Subject: Transmittal of Revision 1 To Service Bulletin Number
V25000-ENG-73-0139.

International Aero Engines SERVICE BULLETIN

ENGINE - FUEL AND CONTROL - REPLACE A FUEL NOZZLE SUPPLY MANIFOLD ASSEMBLY AND
THE RELATED ATTACHING HARDWARE

V2500-ENG-73-0139

Location of the Fuel Nozzle Supply Manifold Assembly
Figure 1 (Sheet 1)

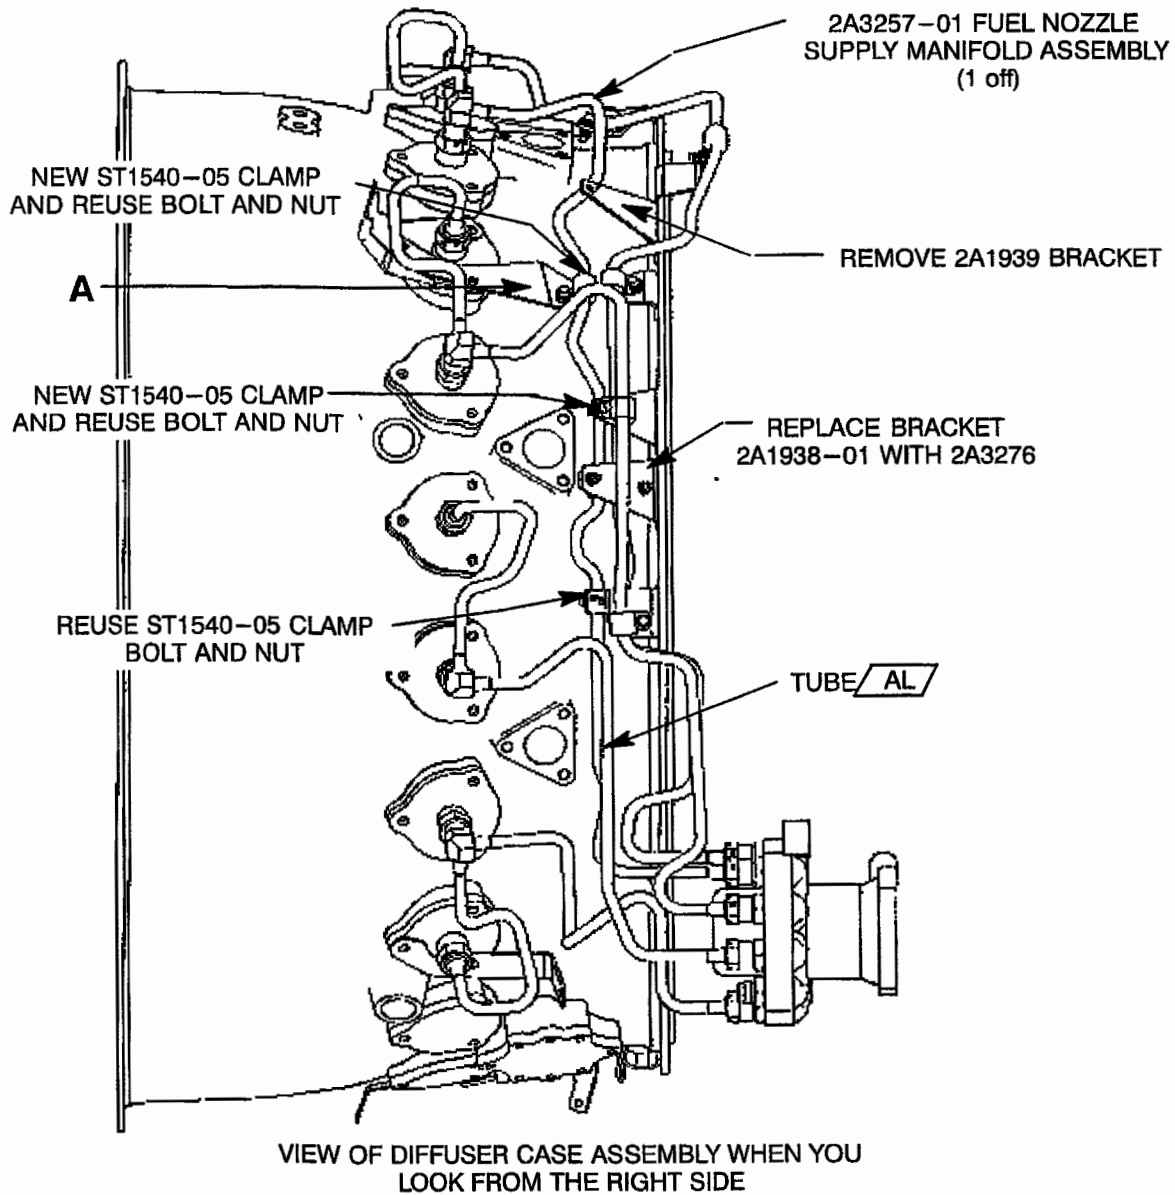
- A. Replace either the 2A3230-01 or the 2A0508-01 Fuel Nozzle Supply Manifold Assembly with the 2A3257-01 Fuel Nozzle Supply Manifold Assembly (1 off), with the parts specified in Figure 1 Sheets 1 and 2, by the procedure given in Reference 4, Engine Manual, Chapter/Section 72-00-40, Installation-07, and as follows:

- (a) Install the bracket by Figure 1 and as specified.

NOTE: Remove the 2A1938-01 Bracket Assembly and the 2A1939 Bracket from the engine when the new configuration is installed. See Figure 1 (Sheets 1 and 2). Remove (2 off) MS122904 Clamps, (1 off) ST1540-05 Clamp, and retain related Bolts and Nuts for reuse.

- 1 Install the 2A3430 Loop Clamp Bracket (1 off) at the No. 3 Fuel nozzle.

NOTE: The 2A3430 Bracket is located on top of the 2A1466 Bracket. Two of the holes in the diffuser case pad are used for bolts that attach both of the brackets.

- (b) Install 2A3276 Bracket on "K" flange by figure 1 and as specified.

- 1 Replace 2A1938-01 Loop Clamp Bracket (1 off) at hole locations 89, 90, and 91.

Location of the Fuel Nozzle Supply Manifold Assembly
Figure 1 (Sheet 2)

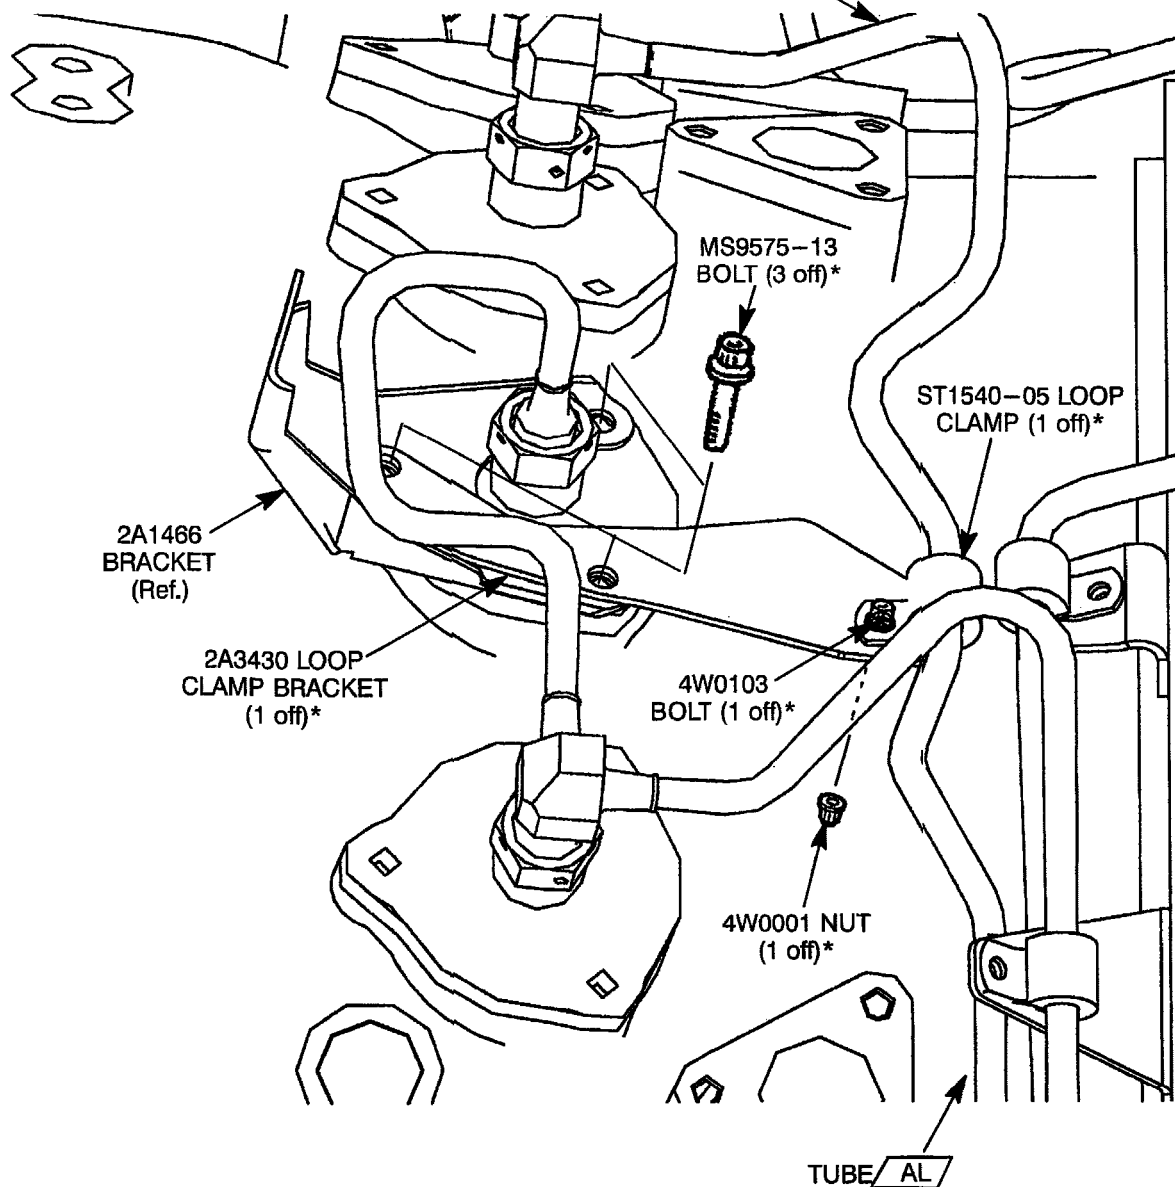
- (c) Install the 2A3257-01 (tube AL) Fuel Nozzle Supply Manifold Assembly (1 off) by the procedure given in Reference (4), Engine Manual, Chapter/Section 72-00-40, Installation-07, and as follows:

2A3257-01 FUEL NOZZLE SUPPLY
MANIFOLD ASSEMBLY (1 off)*

*THESE PARTS MUST BE INSTALLED

Family Tree - Ref. Catalog Sequence No 73-11-41. Fig. 01 Item 160
Figure 2

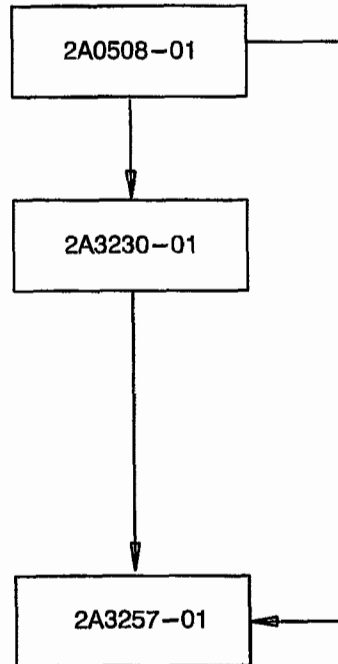
V2500-ENG-73-0088
ENGINE - FUEL AND CONTROL - REPLACE
THE FUEL NOZZLE SUPPLY MANIFOLDS
(V2500-A1, V2527-A5 AND V2530-A5 ONLY)
AND REMOVE THE GASKET OPTION AND
REVISE THE INSTALLATION PROCEDURE
(FOR ALL MODELS)

V2500-ENG-73-0139
FUEL AND CONTROL - REPLACE
A FUEL NOZZLE SUPPLY MANIFOLD
ASSEMBLY AND THE RELATED
ATTACHING HARDWARE

PART NUMBER CHANGE
